SUBMITTAL OF HANFORD FACILITY RESOURCE CONSERVATION AND RECOVERY
ACT (RCRA) PERMIT MODIFICATION NOTIFICATION FORM 24590-LAW-PCN-ENV-
07-001

Modification Notification Form 24590-LAW-PCN-ENV-07-001 updates the Piping and
Instrumentation Diagrams (24590-LAW-M6-LFP-P0001 and 24590-LAW-M6-LFP-P0003) for
the Low-Activity Waste Melter Feed Process System, Melter Feed Preparation, and Melter Feed
(LFP-VSL-00001/2/3/4) found in Appendix 9.2 of the Reference.

Hanford Facility RCRA Permit Modification Notification
Form 24590-LAW-PCN-ENV-07-001

24590-LAW-PCN-ENV-07-001

24590-LAW-M6-LFP-P0003

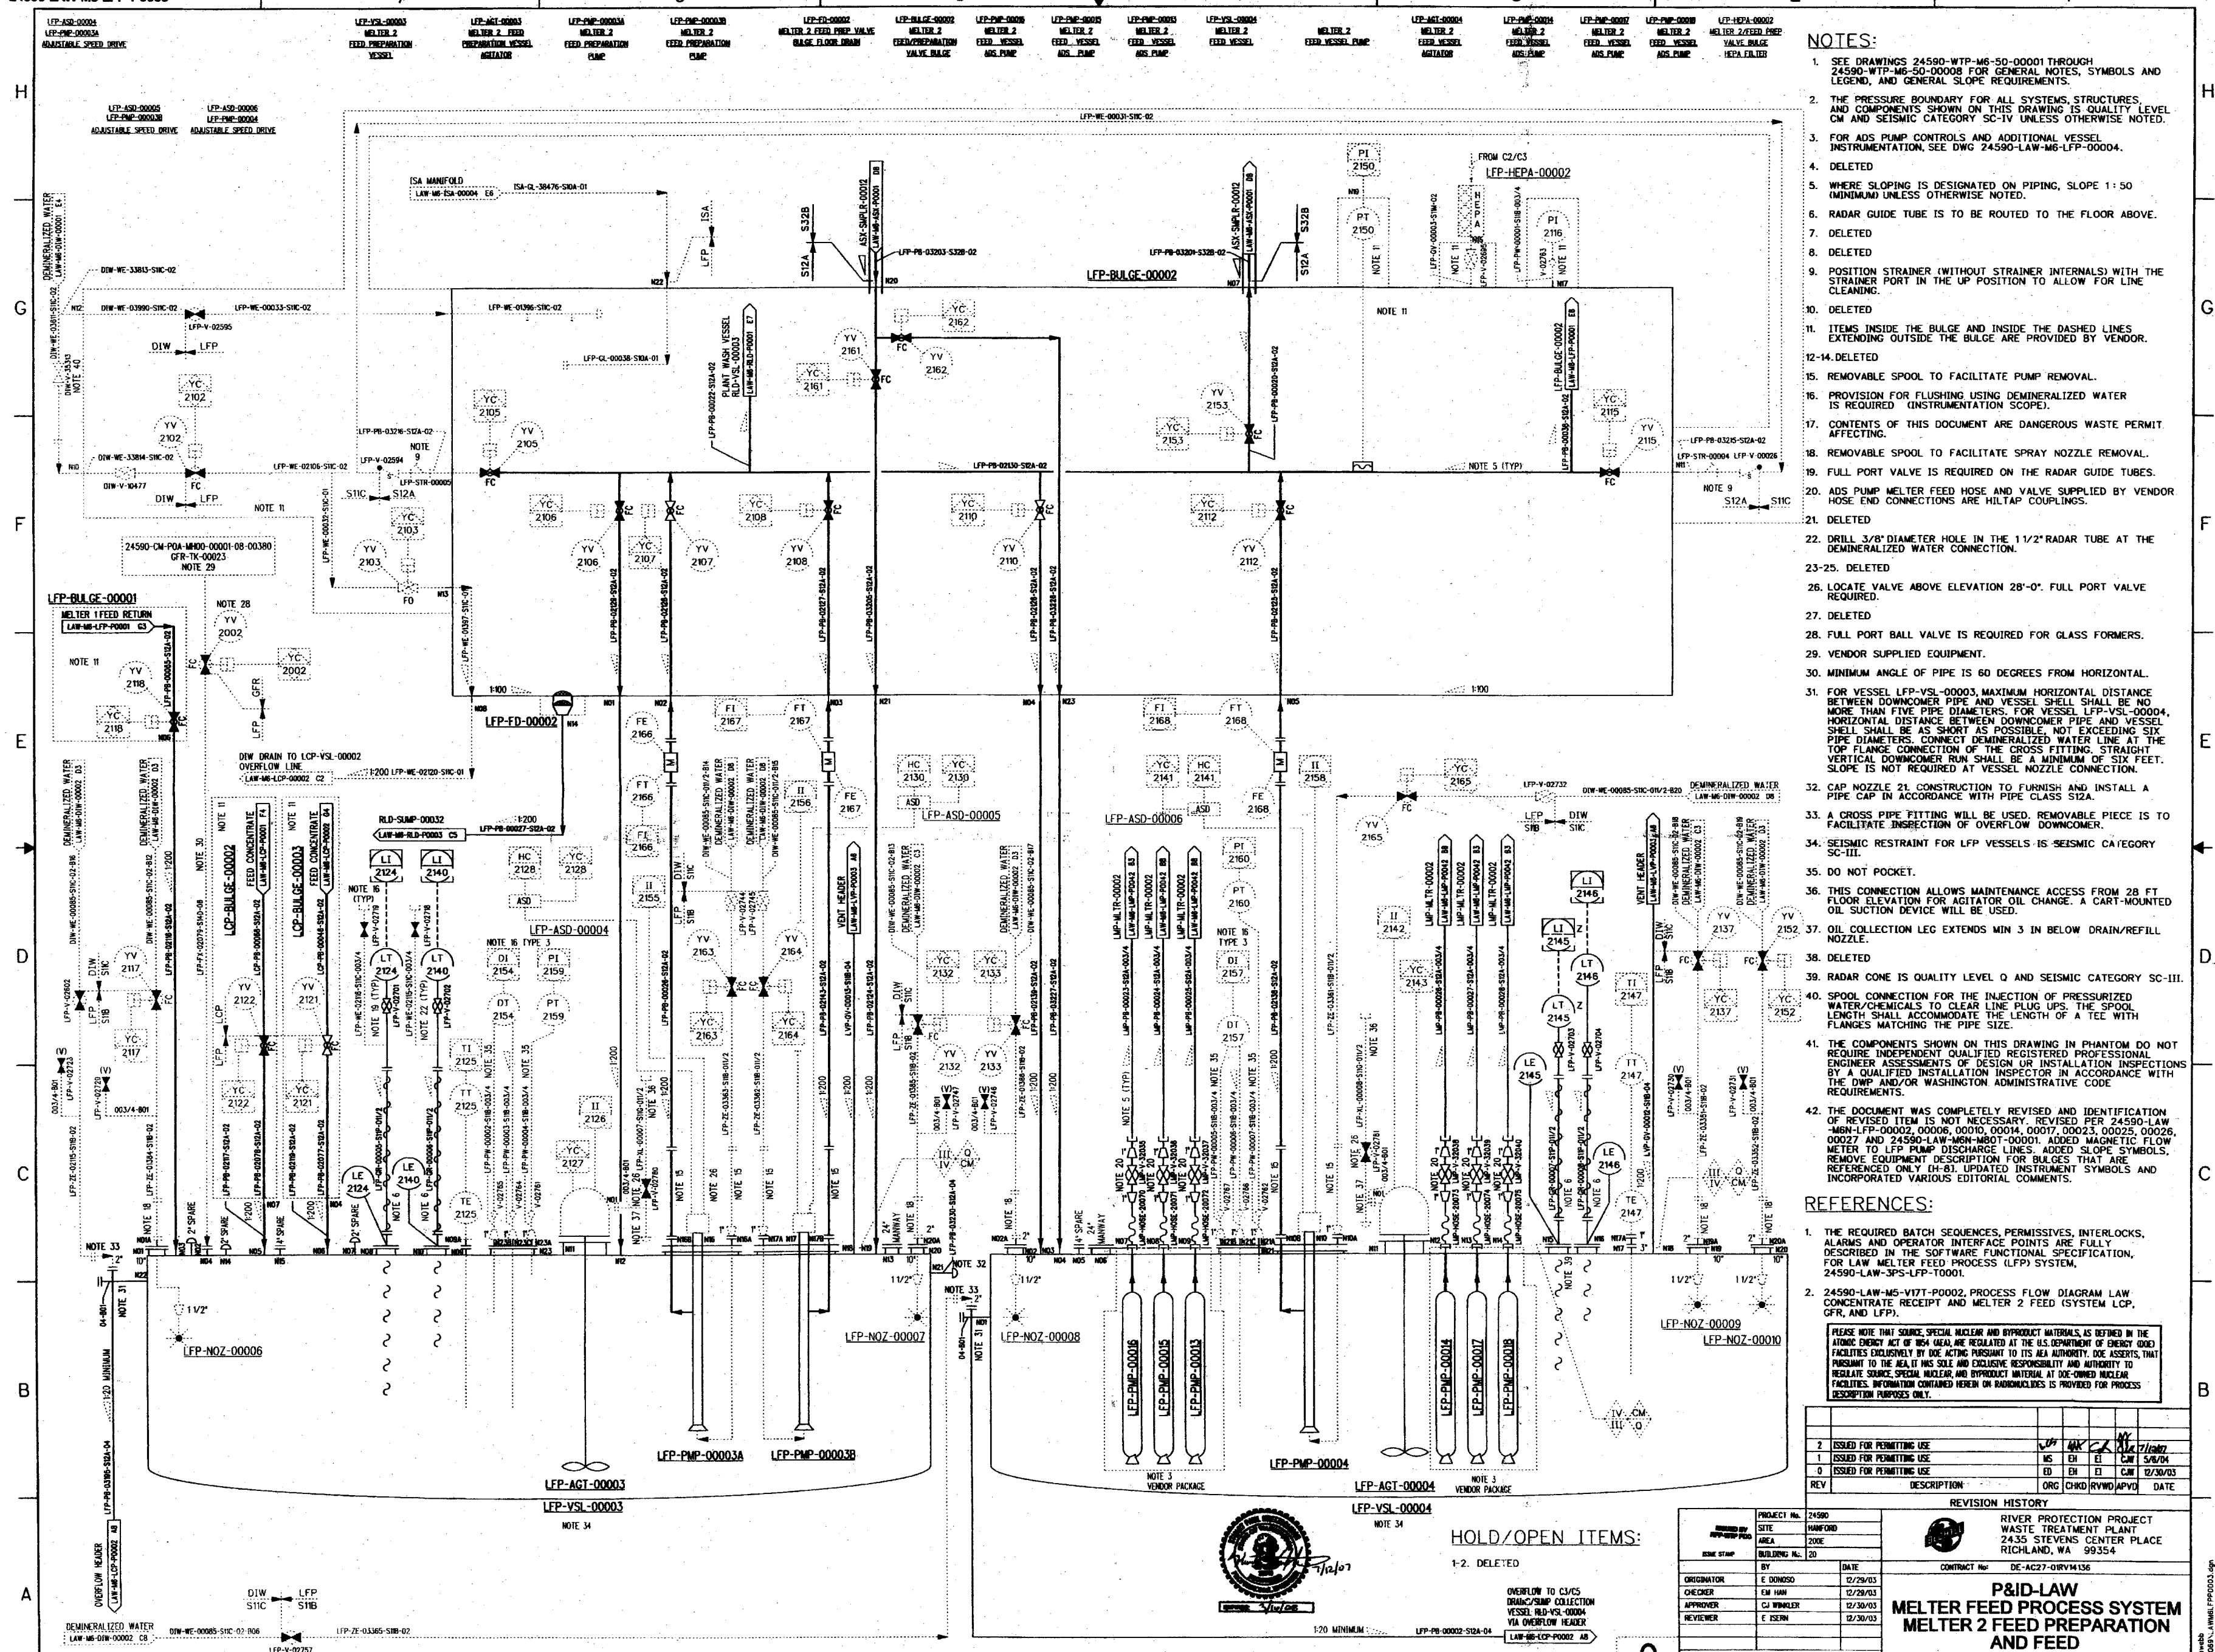
24590-LAW-M6-LFP-00003

- Added slope notation to specific lines
- Revised and added new notes
- Modified ASD pump discharge line valve numbers and added magnetic flow meters as applicable
- Capped nozzle N21 and added a line number
- Rerouted overflow lines and added branches for cleanout
- Changed quality designator of drawing from CM to Q
- Removed equipment description for LFP-BULGE-00003
- Added various ITS identifiers
- Reworded various off-sheet connector descriptions

24590-LAW-M6-LFP-P0001

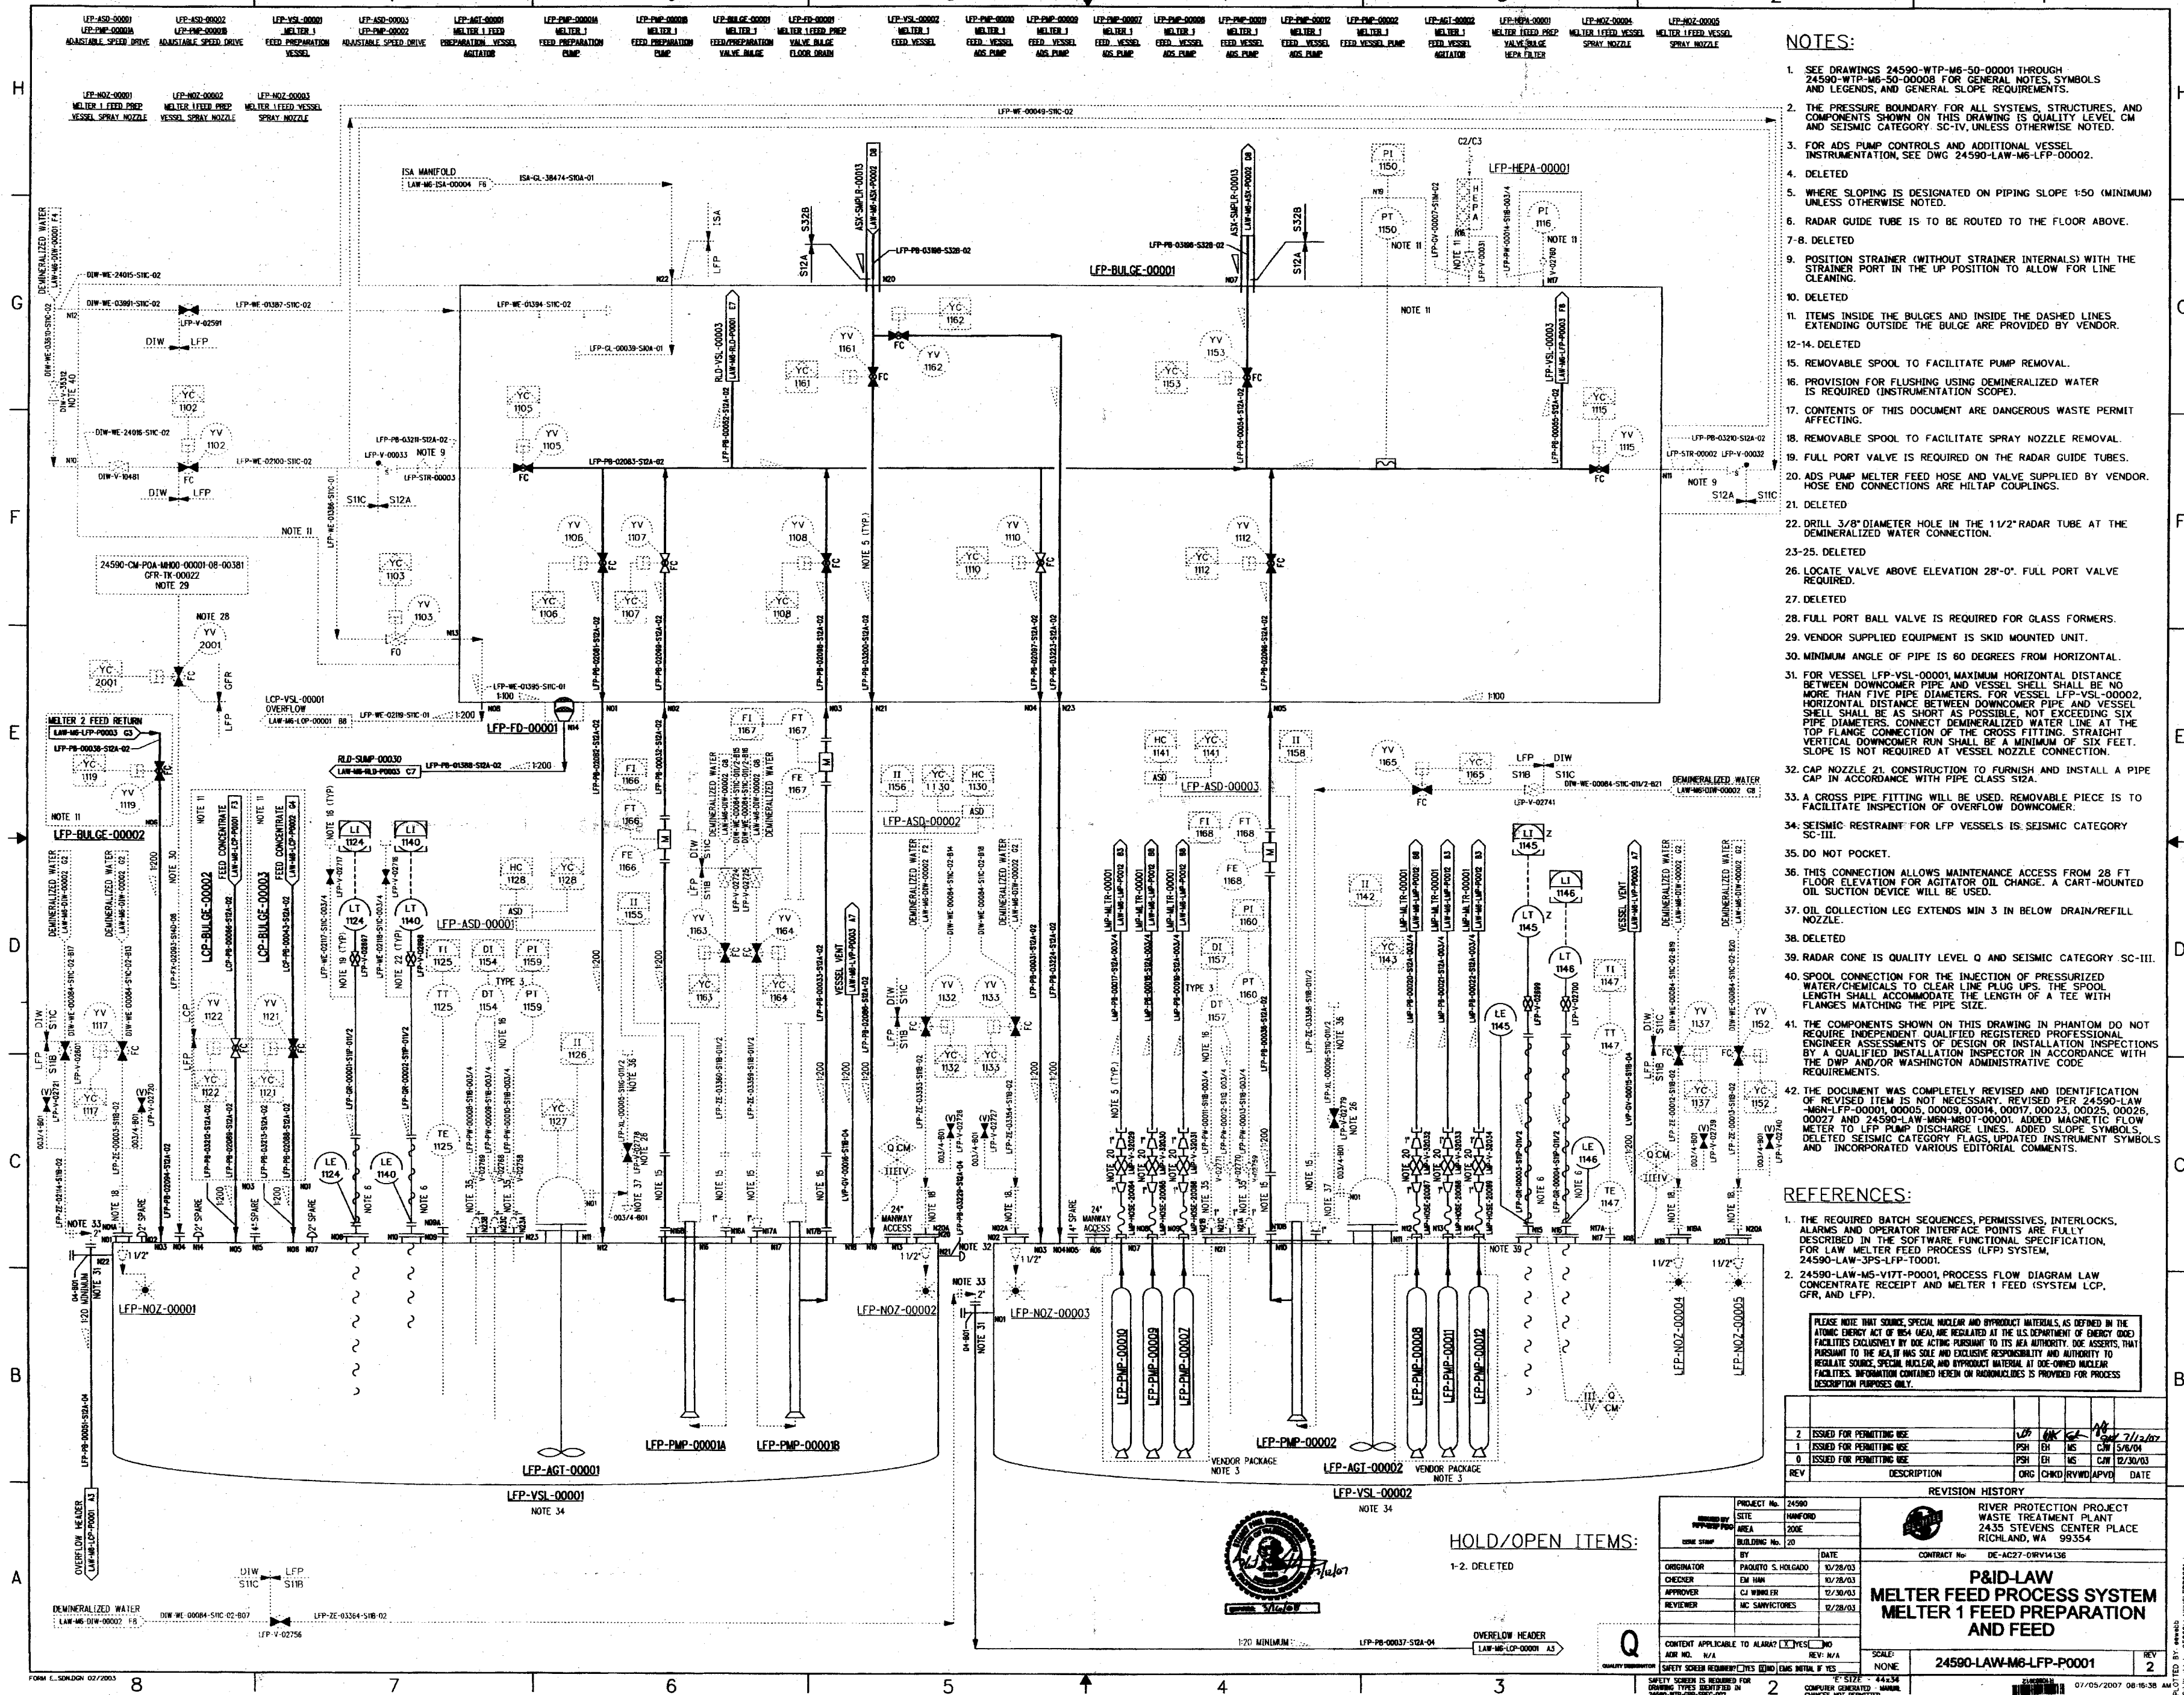
24590-LAW-M6-LFP-00001

- Added slope notation to specific lines
- Revised and added new notes
- Rerouted sample supply and return lines
- Modified ASD pump discharge line valve numbers and added magnetic flow meters as applicable
- Capped nozzle N21 and added a line number
- Rerouted overflow lines and added branches for cleanout
- Changed quality designator of drawing from CM to Q
- Added various ITS identifiers
- Reworded various off-sheet connector descriptions
